THE BID DOCUMENTS, CONDITIONS OF CONTRACT, DRAWINGS AND SPECIFICATIONS ARE HEREBY AMENDED, AS FOLLOWS:

END OF ADDENDUM 6

Drawing Title
**Ground & Second Floor
Plan - Renovation**

For
Algonquin and Lakeshore Catholic District
School Board
Drawing Title
Reflected Ceiling Plan
Second Floor
Date: 04-25-2024 Project No: 22026 Drawing No: A702
Drawn by: AB, JJ Scale: As indicated

© Copyright Reserved.
These drawings and all that is represented herein are the exclusive property of Salter Pilon Architecture Inc. They may not be used or reproduced without written permission from Salter Pilon Architecture Inc.

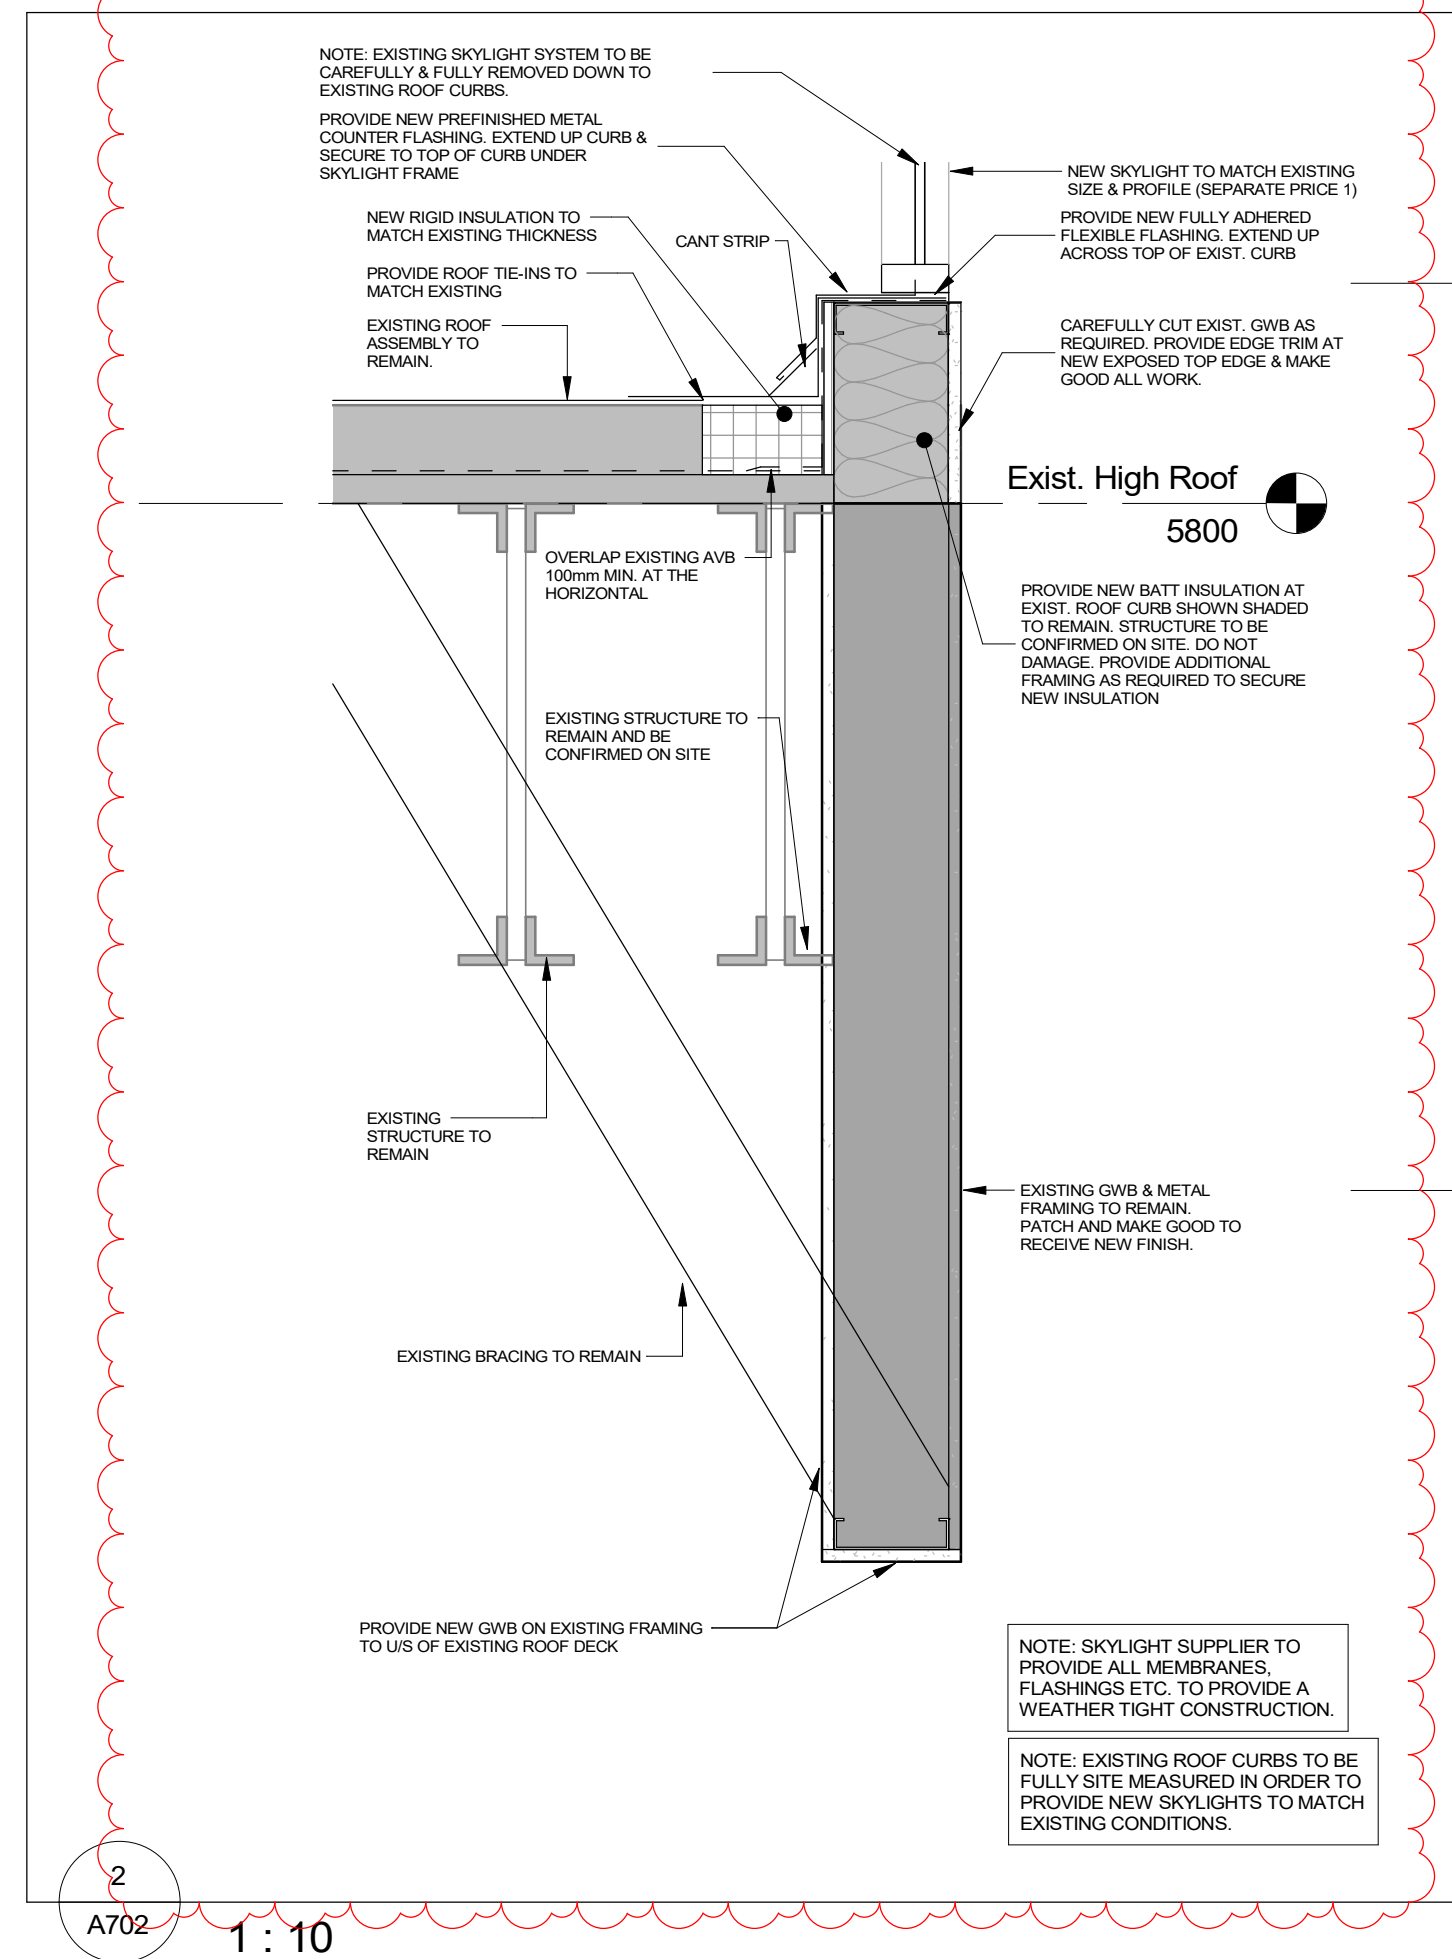
- A204 – Ground & Second Floor Plan – Renovation
 - Additional door to be provided in Ex. Mechanical Room
- A205 – Roof Plan
 - Additional door to be provided in Ex. Mechanical Room
- A301 – Building Elevations
 - Additional door to be provided in Ex. Mechanical Room
- A304 – Window & Interior Screen Elevation
 - Skylight details added.
- A601 – Interior Elevations & Door Schedule
 - Additional door to be provided in Ex. Mechanical Room
- A702 – Reflected Ceiling Plan Second Floor
 - Skylight details added.

“You have asked for a separate price to replace the existing skylight. Please provide details for this work as nothing has been provided.”

Response: Please refer to architectural details provided per amendment 2.

Drawing Title
PLUMBING NEW WORK- UNDERGROUND

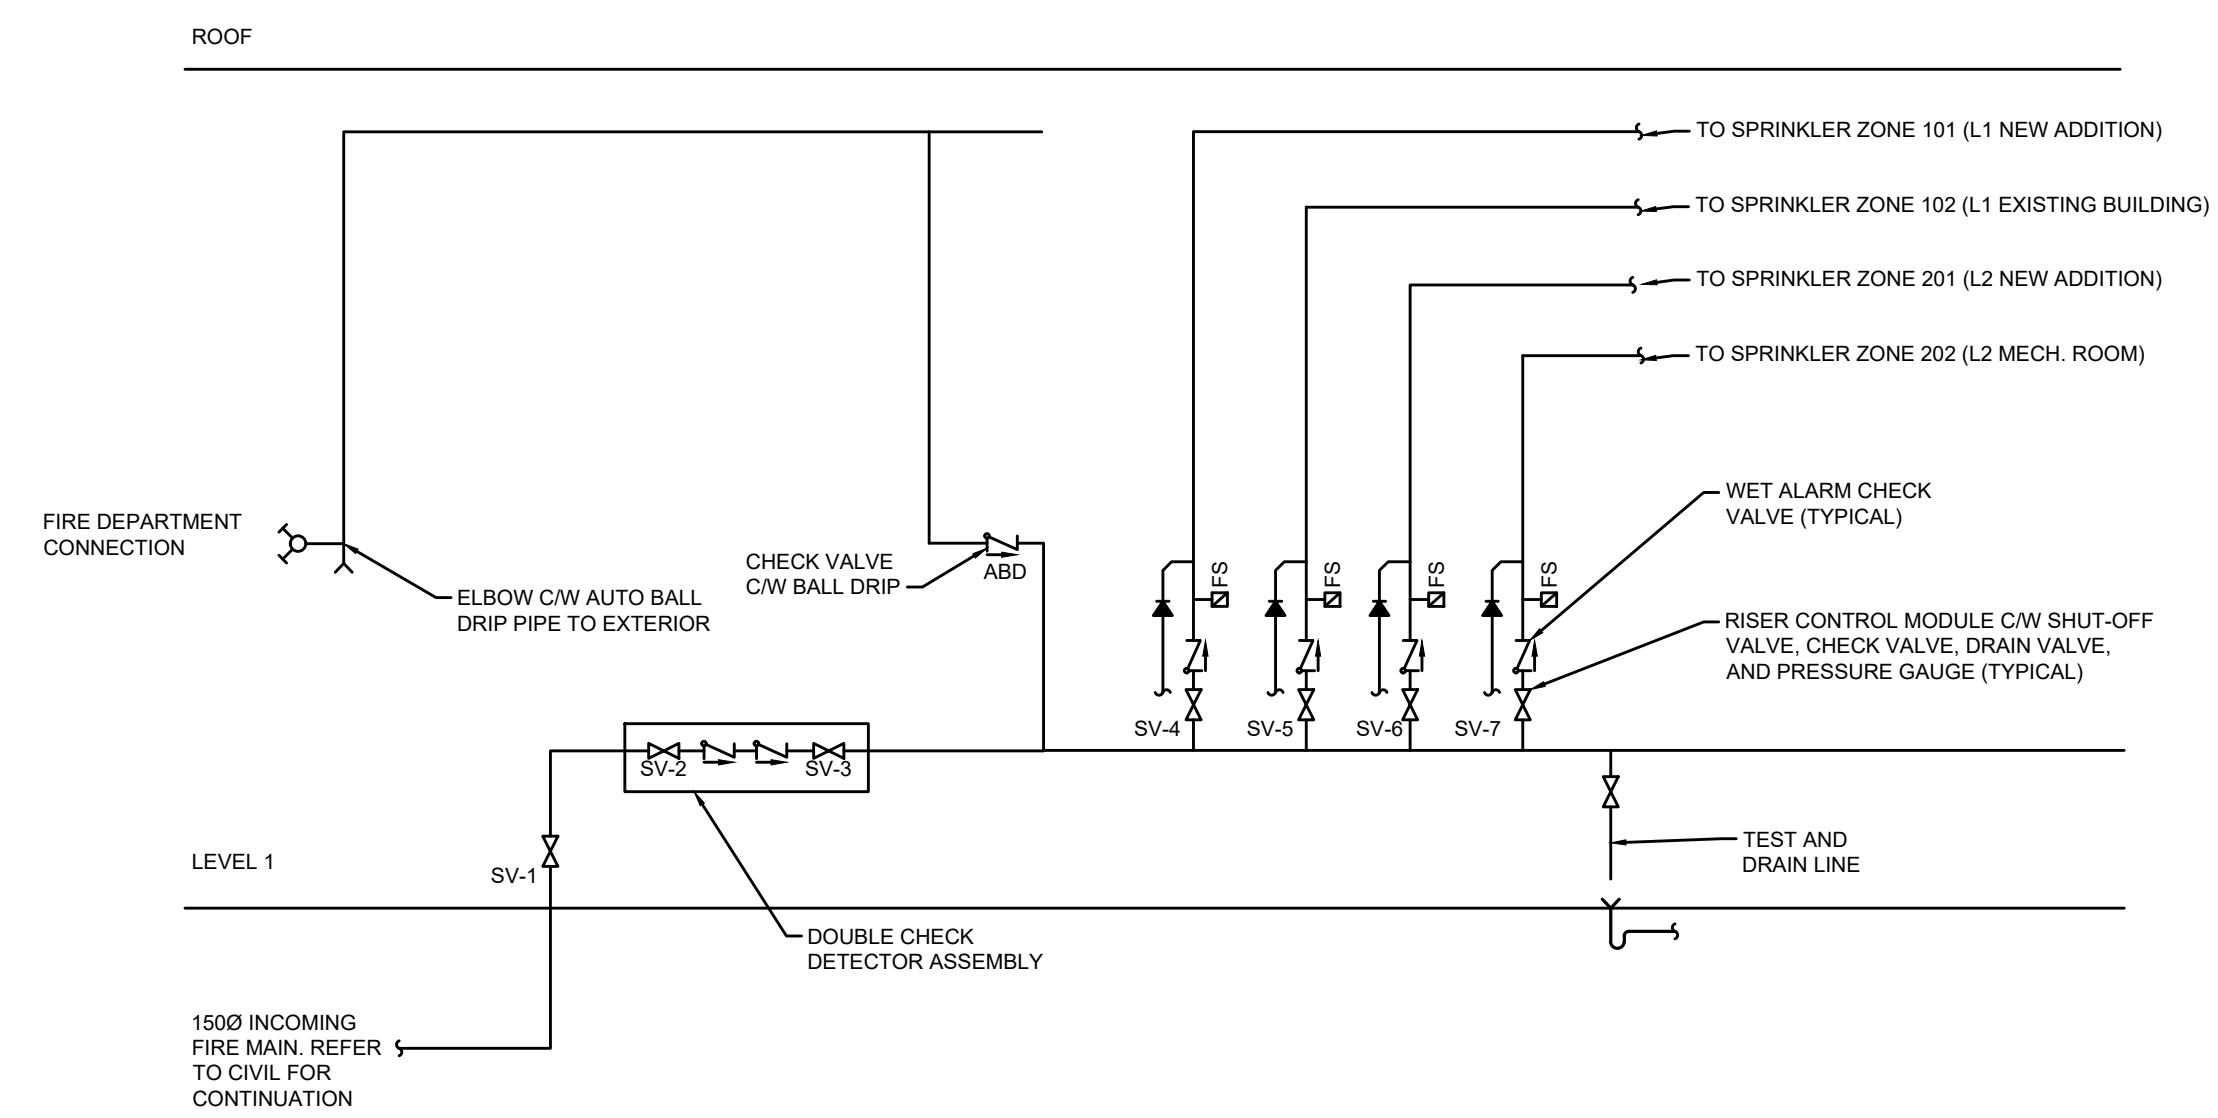
1. **M-250– PLUMBING NEW WORK – UNDERGROUND**
 - a. Revised elevator sump pit to be pre-fabricate sump pit.
2. **M-707– FIRE PROTECTION SCHEMATIC**
 - a. Revised Supervised Valve Schedule as shown.
3. **M-803– MECHANICAL TYPICAL DETAILS IV**
 - a. Revised detail of Elevator Sump Pump & Pit Sanitary Discharge to show pre-fabricated sump pit.
4. **M-901– MECHANICAL SCHEDULES II**
 - a. Revised Schedule of Rooftop Units to account for revised model numbers.

Drawing Title
**FIRE PROTECTION
SCHEMATIC**

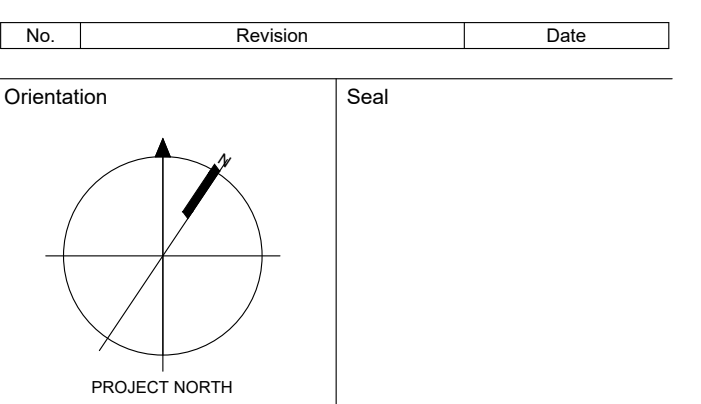
- a. **No, cabinets are not required for zone control riser modules within Sprinkler Room.**
2. Drawing M-707 supervised valve schedule calls for an SV-3 to be a fire pump control valve? is there a requirement for a fire pump?

- a. **No, a fire pump is not required. Supervised valve schedule has been revised as a part of this addendum.**
3. Is there an existing sprinkler system in the building? The drawings are unclear regarding this. Are there any pictures/ drawings of any modifications that need to happen to any existing sprinkler systems?
